Moolarben Coal Complex Stage 2 _ Preferred Project Report 08_135

I wish to lodge my objection to the Moolarben Coal Complex (MCC) Stage 2 Preferred Project Report (PPR). This proposal falls well short of the environmental requirements that would be necessary to offset and mitigate the prospective water catchment degradation and biodiversity loss emanating from this mine. It fails to provide adequate compensation to the local community and future generations for the scale and impact of the project predicted to endure in excess of 100 years.

Fig 2.5 - MCC Transect 4 - with Drip seepage zone height corrected to 8-12m
PZ129 superimposed (depth to scale - from LOG)

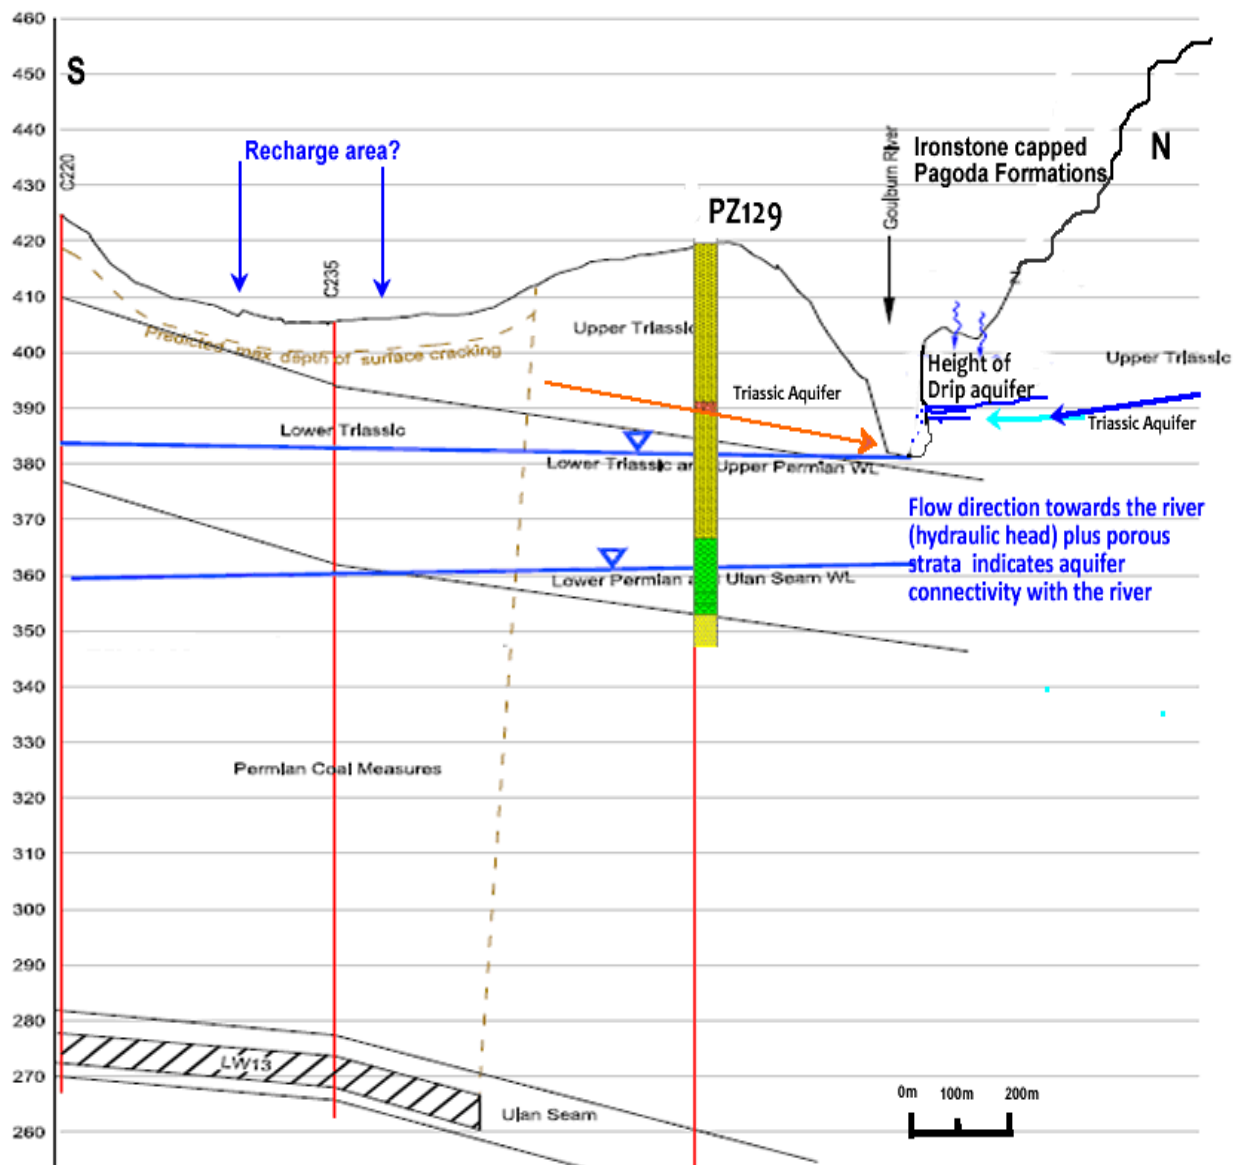
Increased vertical hydraulic permeability due to mine subsidence occurred above UCML underground prior to 2006 and the installation of the wider long wall faces. Table 5.9 (p.48 MCP GIA) shows increasing mine inflows from the 1990s, accelerating in 2000-2002 wet years (from 5.6- 7.7 ML/day). Triassic Bore PZ129 has a hydraulic head range 390-393mAHD (MCC AEMR 2010-11) this is above the level of the river (~382m AHD) indicating groundwater flows towards the River (see Fig2.5).

The GDE referred to as ‘The Drip’ has not been adequately investigated or understood. Local knowledge will confirm that seepage is sustained throughout the severest of droughts; this resilience suggests it is fed by a permanent groundwater source located above the ‘dripping’ discharge area (~ 390 mAHD - halfway up the cliff face). While the aquifer would obviously rely on replenishment from rainfall events, it may also be sustained from upward pressure from joint or fault connecting it to the Triassic aquifer system (Pz129 = 389-392 mAHD) and therefore could be potentially drained if the Triassic Aquifer was depressurised. The water level in hydraulic head of Triassic Bore PZ 129c (opposite The Drip) indicates groundwater flow towards the river.
